**MONTANA LIMESTONE RESOURCES OPERATING PERMIT APPLICATION  
MLR RESPONSES TO DEQ 29 MARCH 2018 REVIEW COMMENTS**

**ATTACHMENTS TO RESPONSE  
TO COMMENT 8**

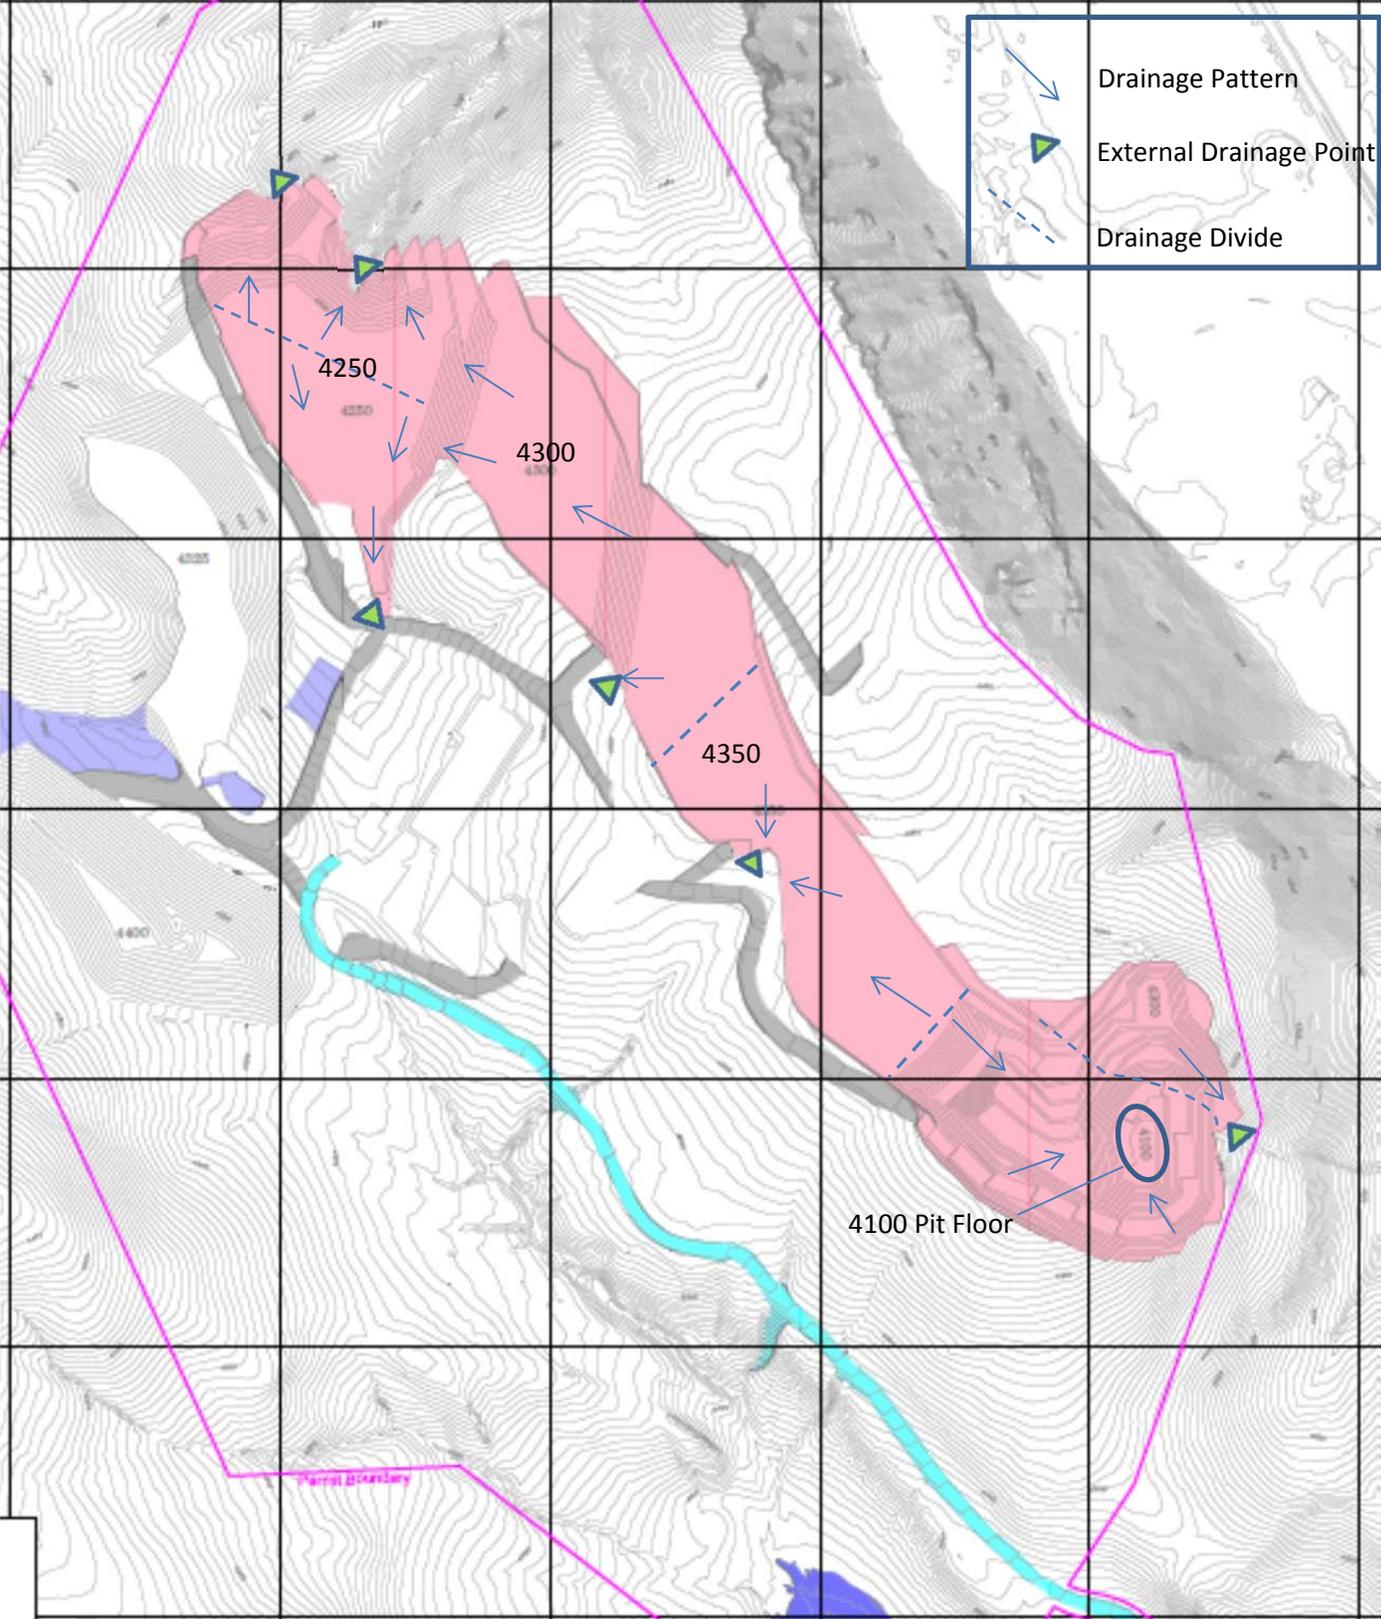
Response to comment #23: DEQ acknowledges that limited amounts of water may be present in the pit from closed perched zones. Please commit to grading the final pit bottom so that any water, be it from perched zones or meteoric water from precipitation events, is free draining out of the pit so no standing water is present. 82-4-336(5), MCA

The only internally draining area will be a portion of the south pit where backfilling is not proposed. Approximately 4.8 acres of the south pit will be graded for external drainage with 17.9 acres internally draining (attached Figure 1). As described in Section 4.9 of the MLR permit application, all benches, ramps and the 4100 pit floor, about 75% of the internally drained area, will be covered with soil and revegetated leaving only the steep highwalls as exposed bedrock. Prolonged ponding, to the extent that it will serve as a host or breeding ground for mosquitos or other disease-bearing or noxious insect life, is not expected in this area either due to the high net ET conditions described below.

As noted in Section 4 of the permit application, the majority of the pit will be backfilled concurrently with mining. Backfilled portions of the pit (comprising over 75% of the total pit area) will be graded for external drainage if necessary to avoid short-term ponding. Attached Figure 1 shows multiple locations where the backfilled pit surface is higher than the surrounding ground and will drain externally.
